ADDENDUM

07TS0163

Andrew Gibb
(Queensgate)

STAFF'S
REQUEST ANALYSIS
AND
RECOMMENDATION

**Queensgate Subdivision
Regional Traffic Distribution on Area Roads**

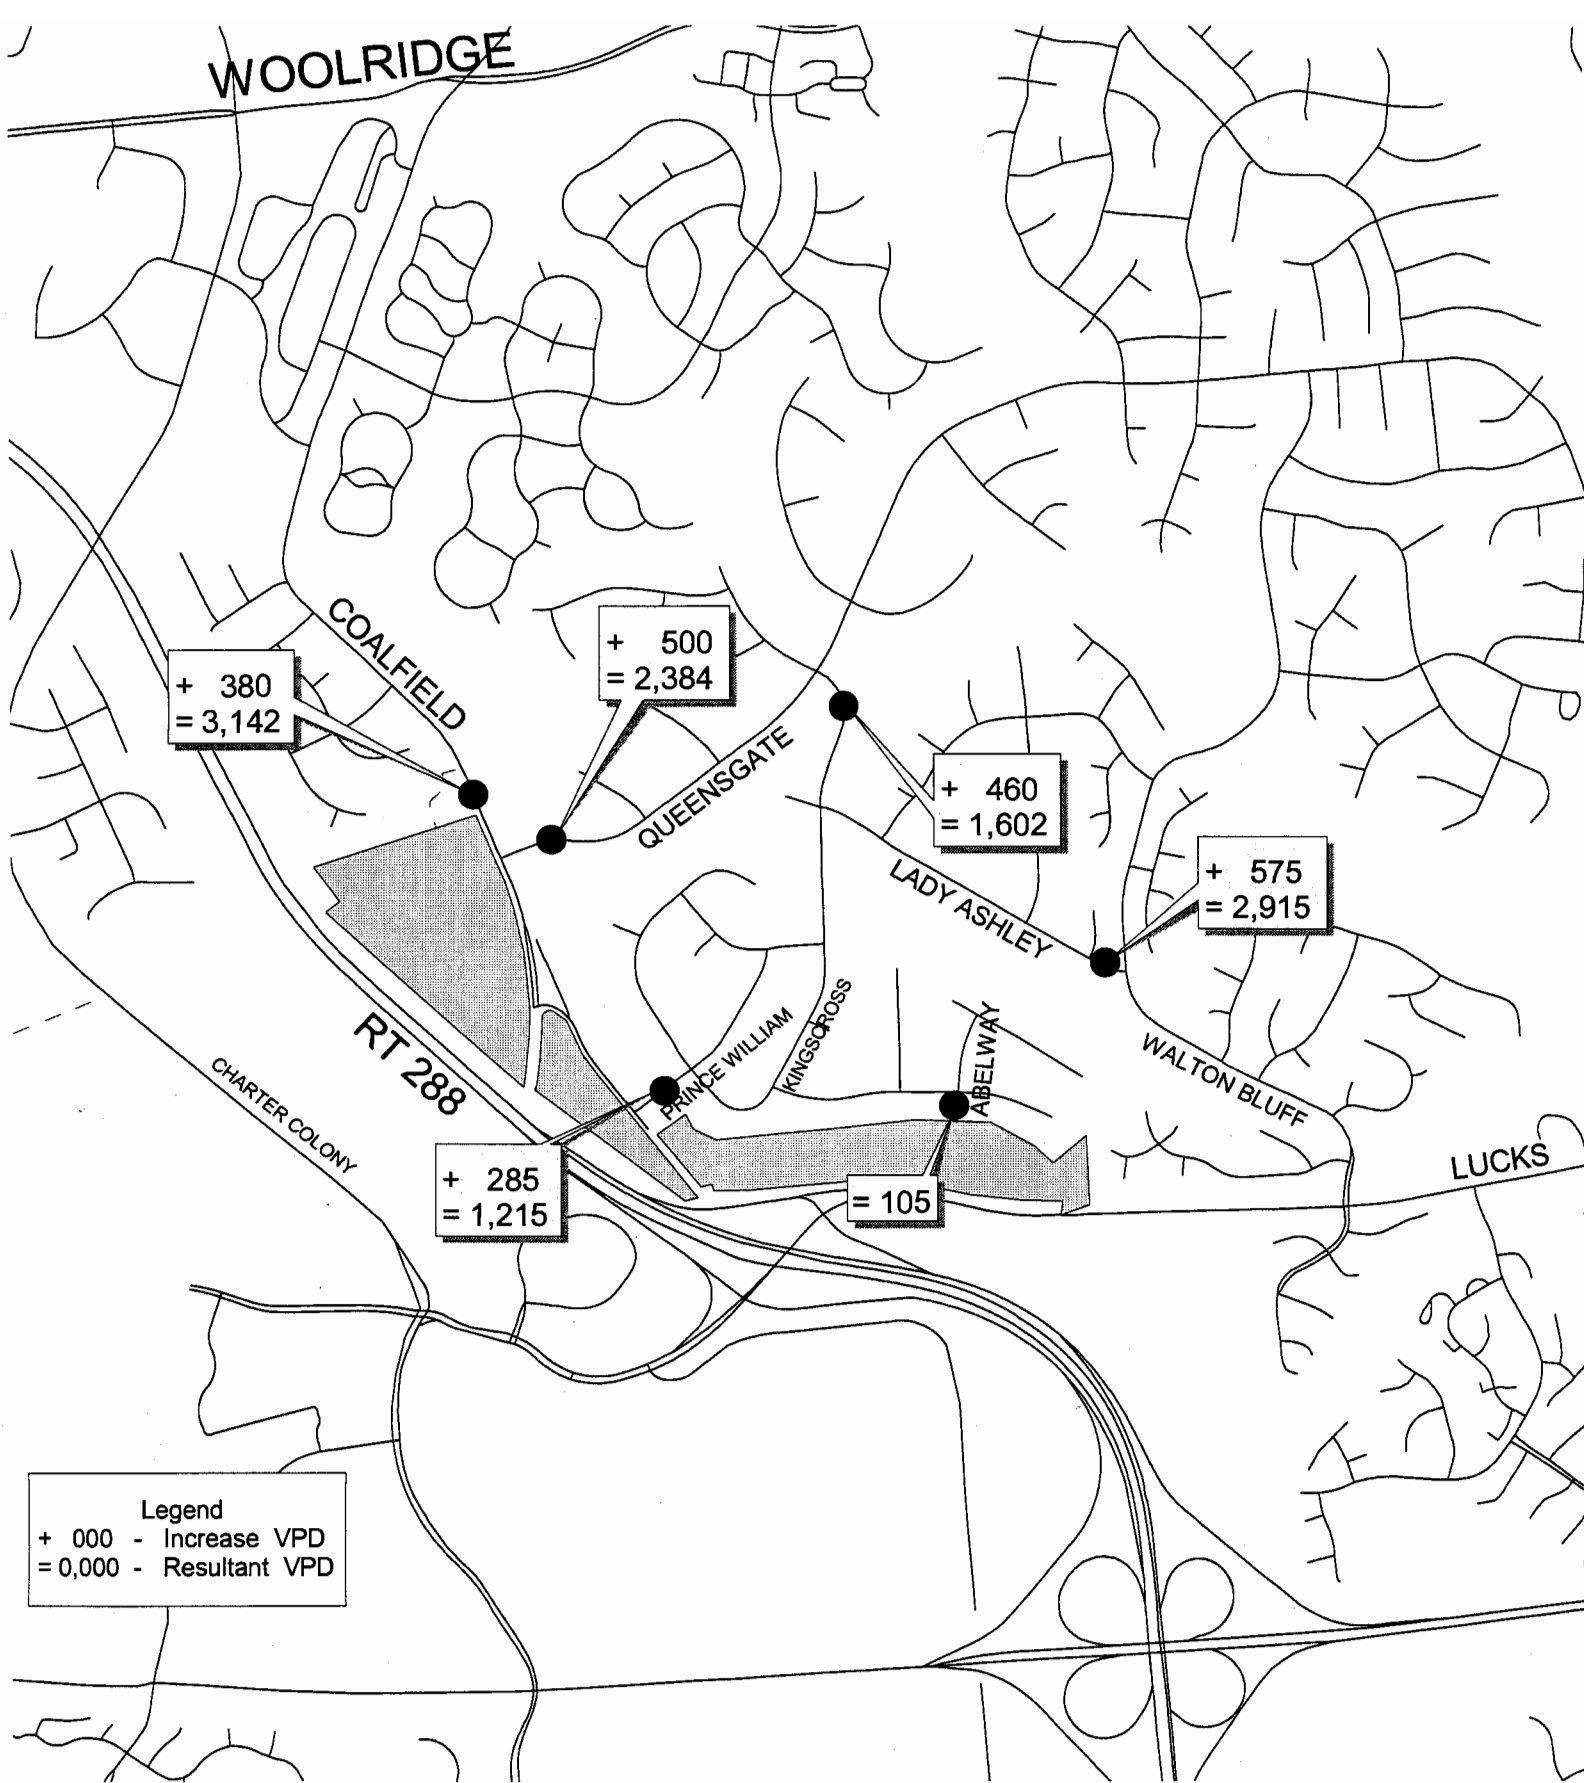
In the Background section of the staff report (page 9, paragraph 2) a reference is made to "attached maps" as part of a discussion regarding regional traffic distribution. The two maps were inadvertently omitted from the staff report and are included here for your review.

Based on the Queensgate Tentative Subdivision Plat, staff assumed a regional distribution of the traffic that is anticipated to be generated by this development onto the streets in Queensmill Subdivision (see attached map). Based on staff’s analysis, below is the anticipated traffic volumes projected for various streets.

<u>Road Segment</u>	<u>Increase VPD</u>	<u>Resultant VPD</u>
Coalfield Rd just north of the proposed Queensgate Subdivision	380	3,142
Prince William Dr at Coalfield Rd	285	1,215
Queensgate Rd between Coalfield & Kingscross	500	2,384
Kingscross Rd between Queensgate & Lady Ashley	460	1,602
Lady Ashley Rd between Queensgate & Walton Bluff	575	2,915
Abelway (stub road right-of-way)	105	105

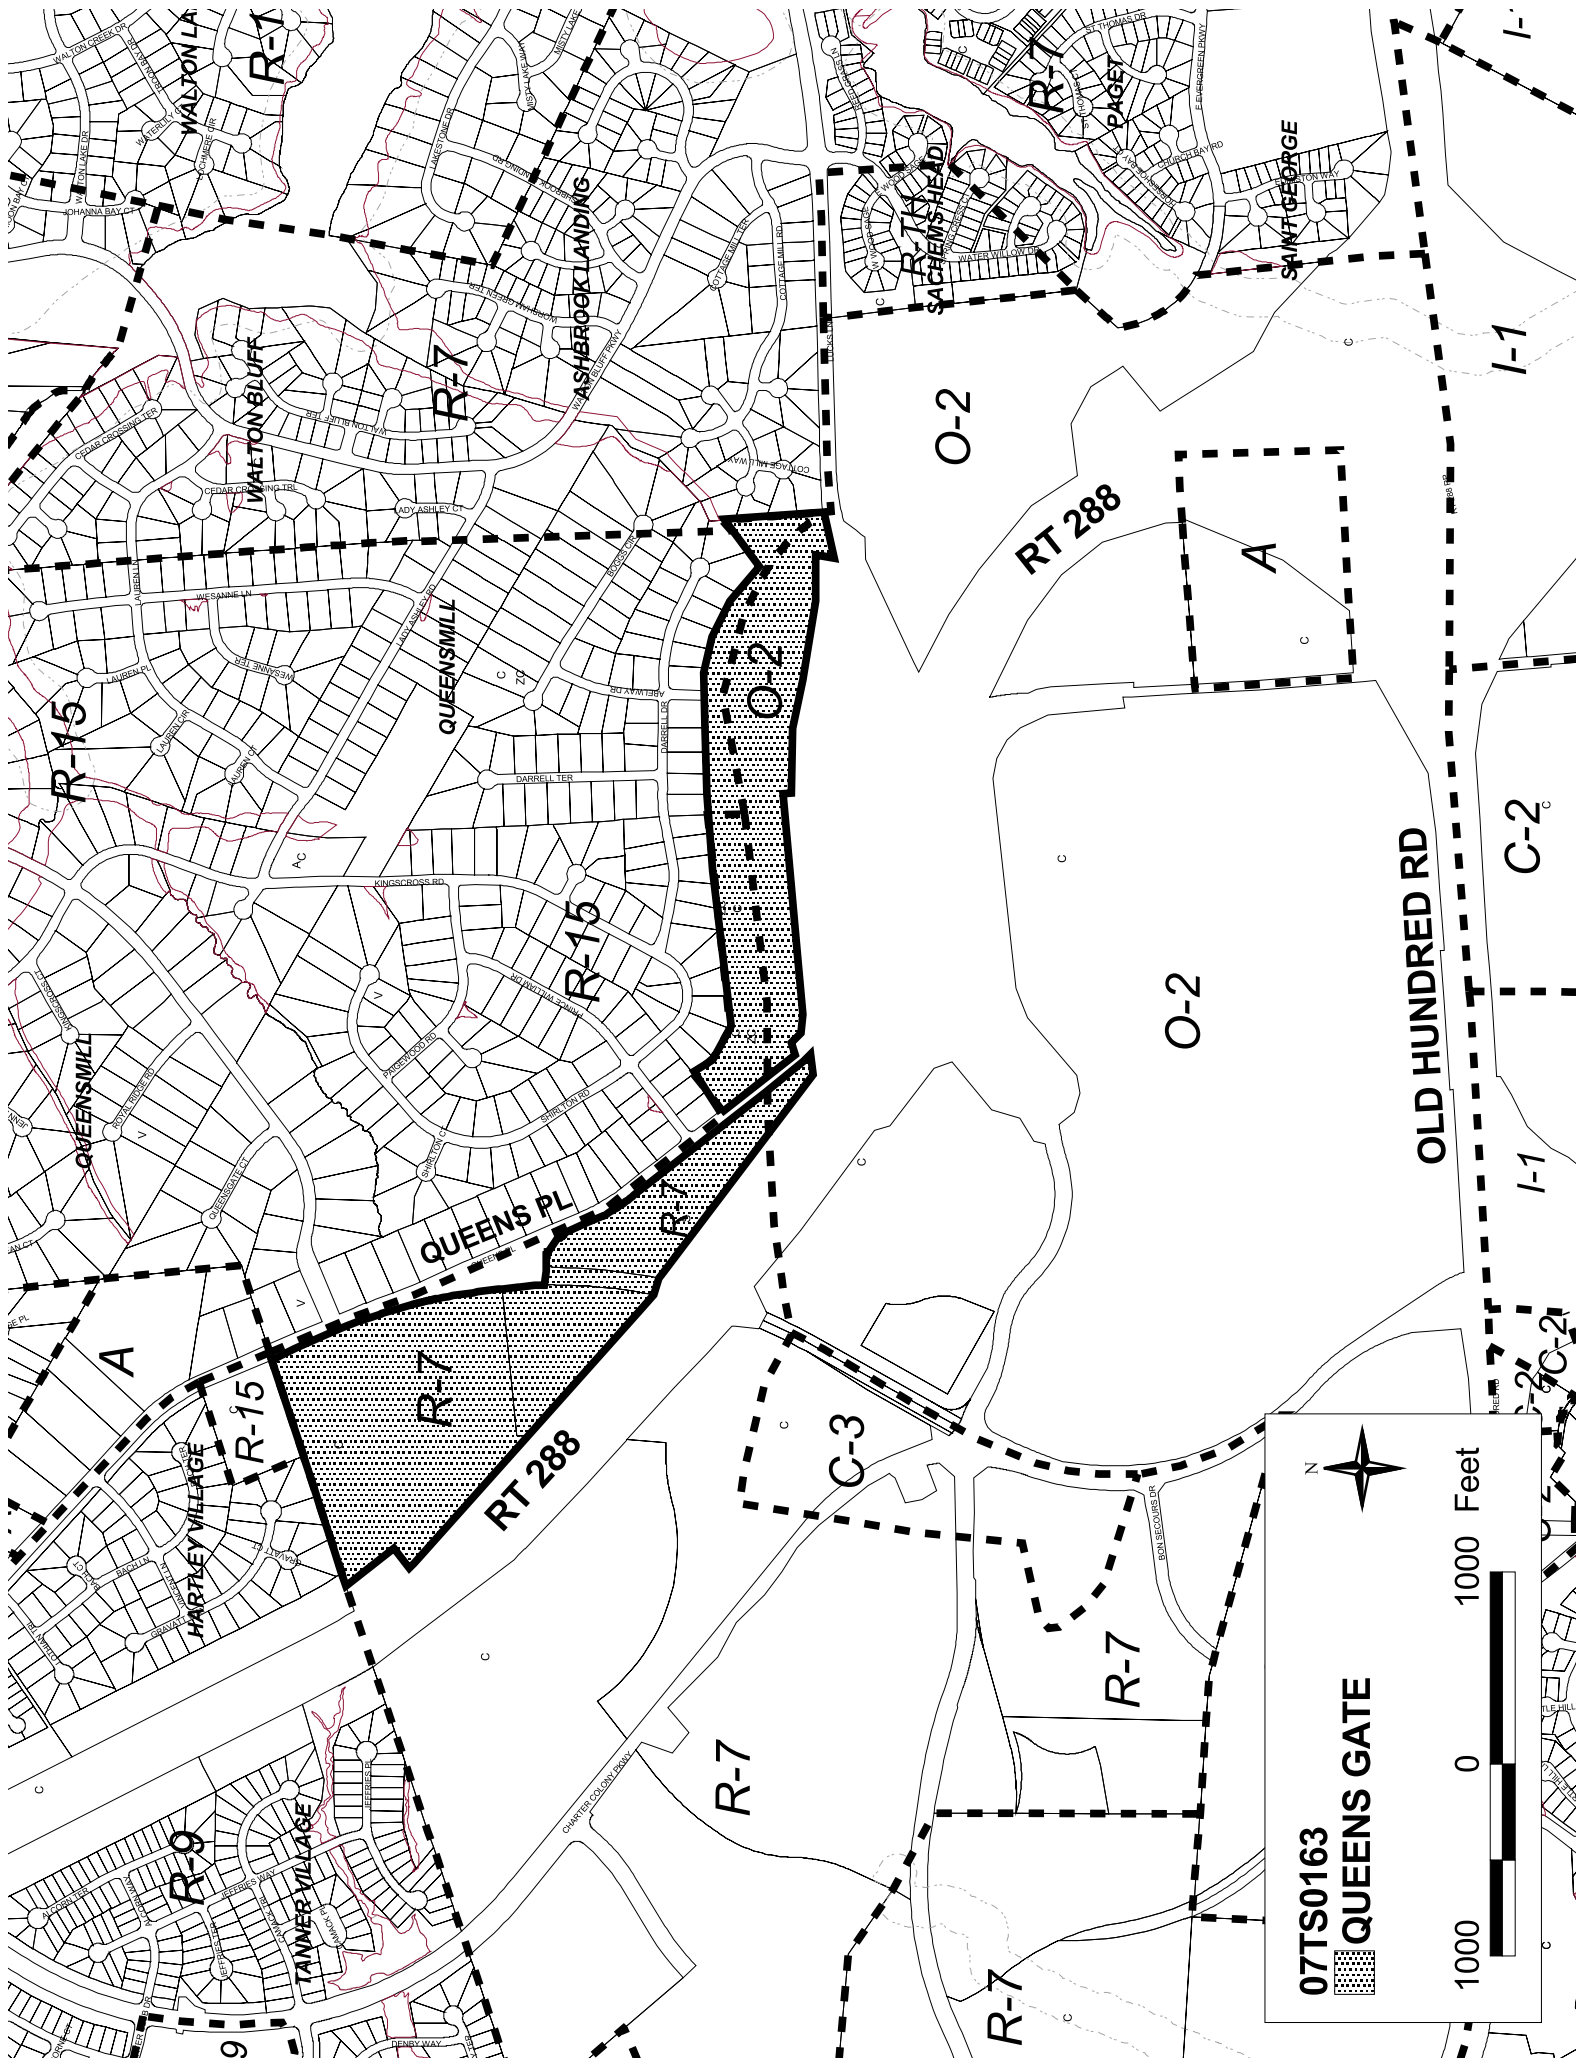
The applicant proposes to reduce the 200 foot setback to 150 foot and construct a fifteen (15) foot high berm for noise attenuation within the limits of the proposed development and adjacent to Route 288 mainline right-of-way. This berm will extend from the terminus of the existing berm, that was constructed with the Route 288 project, to the northern property line. In addition, a fifty (50) foot setback is proposed along the limited access interchange right-of-way on Lucks Lane for a portion of lot 111 and all of lots 112 through 124 and a 100 foot setback for lots 102 through 110, and a portion of lot 111. Staff consulted with the Virginia Department of Transportation (VDOT) Environmental Division regarding noise abatement and the applicant’s

proposal. Staff recommends approval of the proposed noise setback along Route 288 as presented on the tentative subdivision plat.
